Subject: Dresden Station Units 2 and 3
Quad Cities Station Units 1 and 2
LaSalle County Station Units 1 and 2
Topical Report for Neutronics Methods for BWR Reload Design
NRC Docket Nos. 50-237/249, 50-254/265, and 50-373/374

Attachment: Commonwealth Edison Response to NRC Questions on Edison Topical Report NFSR-0085

Commonwealth Edison Response to NRC Questions on
Edison Topical Report NFSR-0085

Figure 1
Comparison of Hot Critical Eigenvalues
Quad Cities 1 Cycle 10

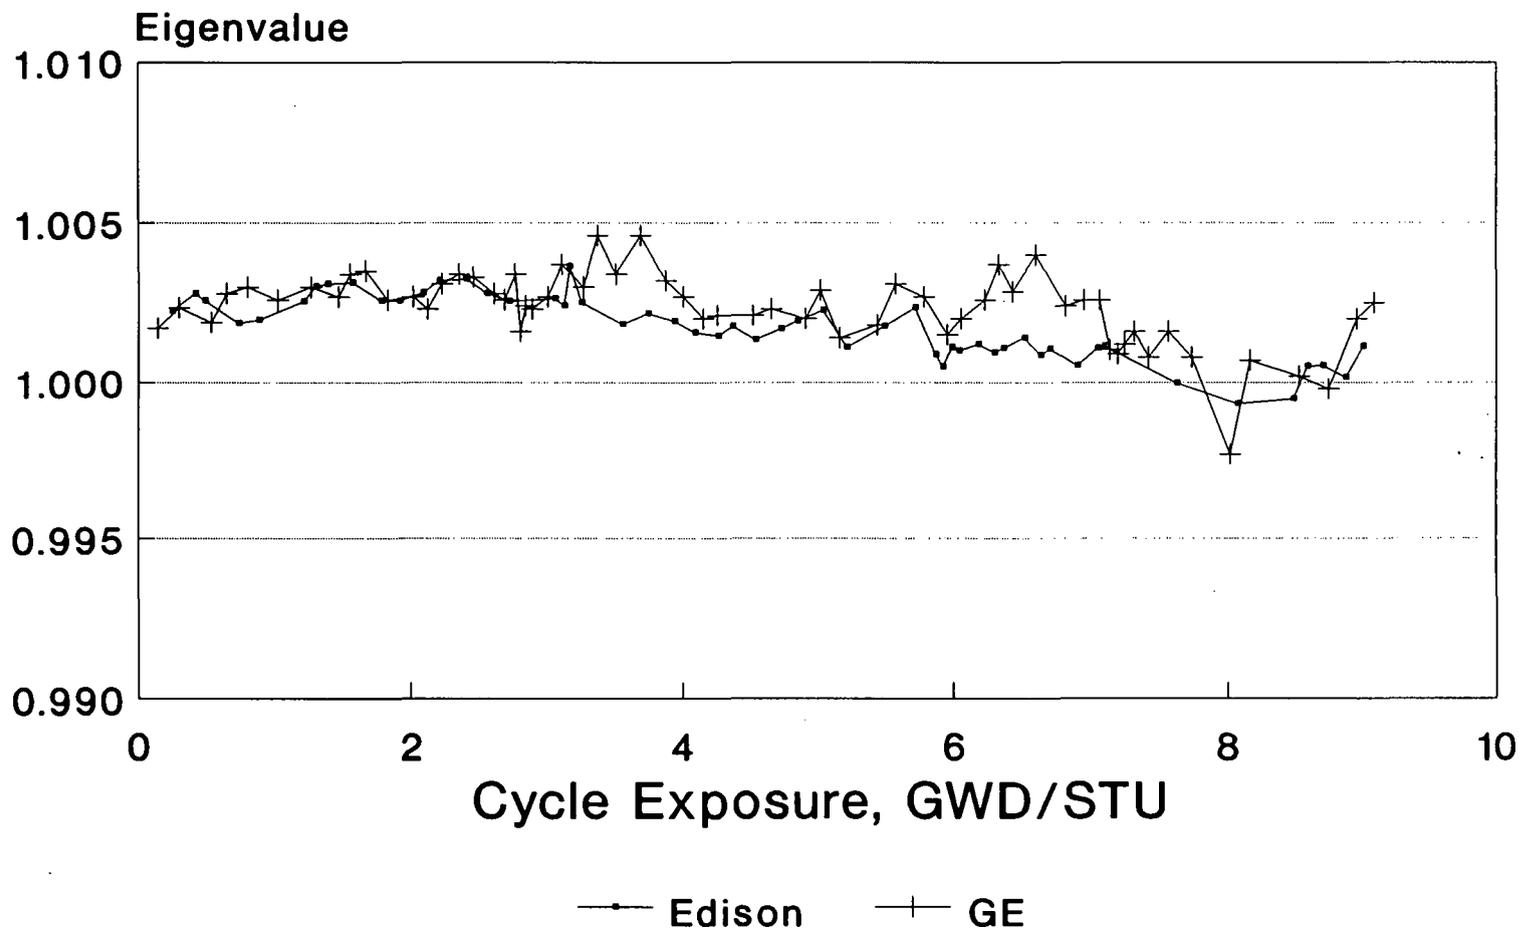
Page 4-2, Sections 4.2.1
Hot Critical Eigenvalue

Comparisons of the GE and Edison results for the hot critical eigenvalues for Quad Cities 1 Cycle 10 and LaSalle 2 Cycle 3 are contained in Figures 1 and 2. The GE data is documented in References 5 and 6, respectively. This data could not be presented in tabular form since the incremental exposure intervals chosen for core tracking were different. The mean and standard

These values demonstrate that the Edison results are approximately the same as the GE values. The difference in mean eigenvalue for Q1C10 is consistent with the data in Figures 1 and 2.

An evaluation of Figures 1 and 2 also show relatively good agreement. The LaSalle 2 comparison is better than the Quad Cities comparison primarily because the operational strategies at the units are different. Hot critical eigenvalue data is most consistent if the unit is operating in steady-state. Quad Cities load follows, both with nightly load drops and daily system Economic Generation Control (EGC), to a much greater degree than LaSalle. Therefore, it is more difficult to select state conditions and exposure increments which approximate the unit operation for a given interval due to xenon transients which results from power changes. The exposures which show the greatest difference for the Quad Cities eigenvalues are those intervals in which the unit was load following significantly.

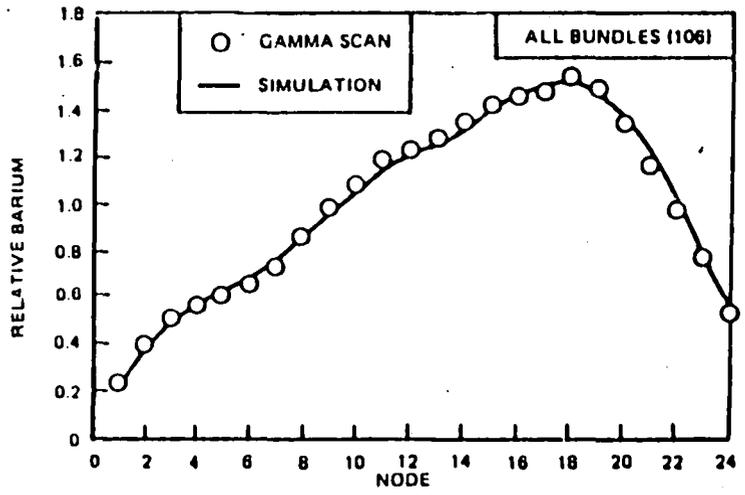
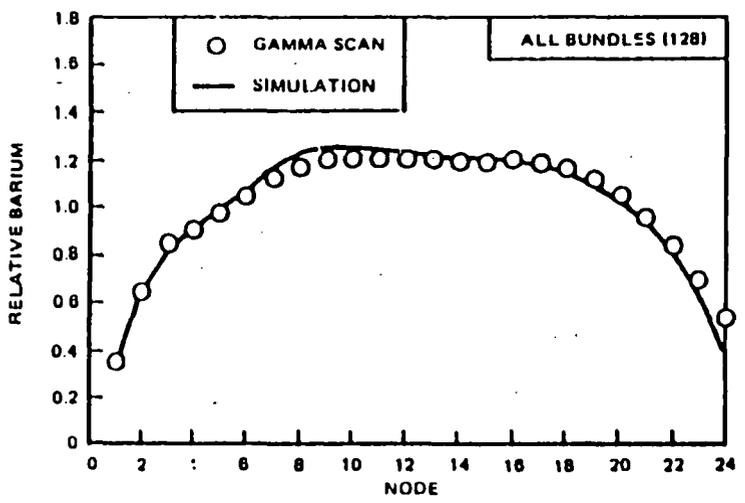
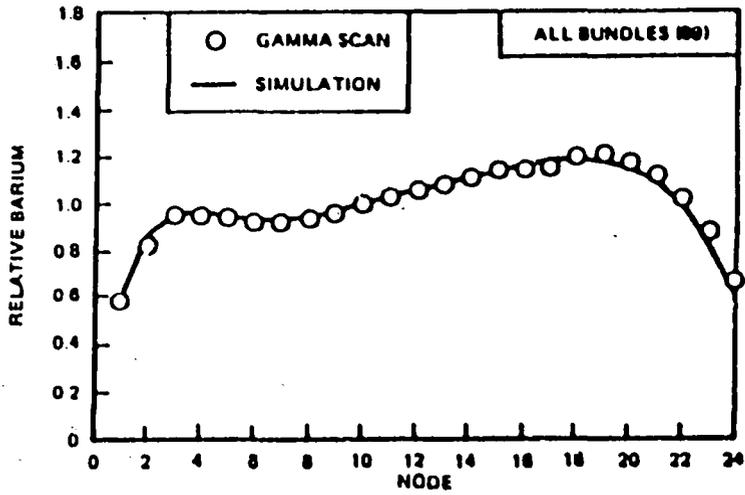
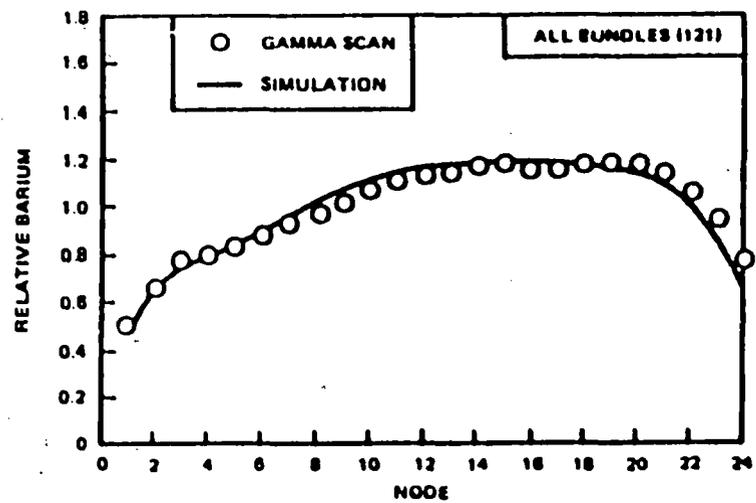
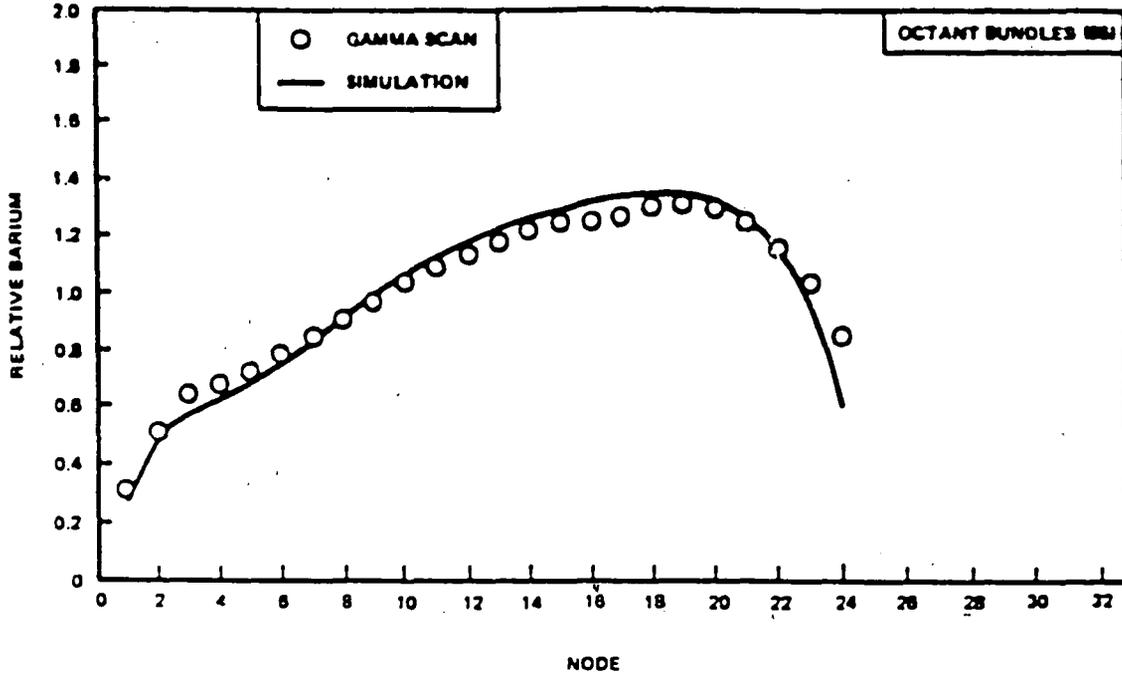
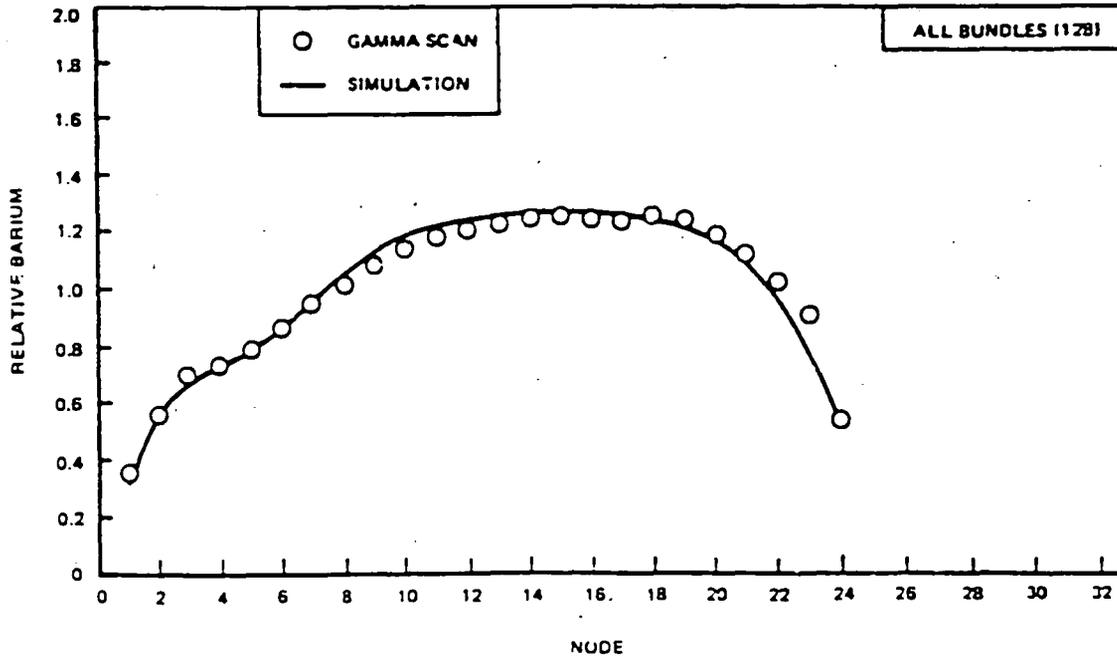
Assembly Gamma Scans

What do similar GE curves look like?

See GE Document NEDE-30130-P-A Pages 5-19 and 5-20 for the relative barium-140 concentrations as a function of axial height. See GE Document NEDE-30130-P-A Pages 5-23 through 5-25 for the percent error in assembly integrated power as a function of core position. A copy of these pages is attached for your use.
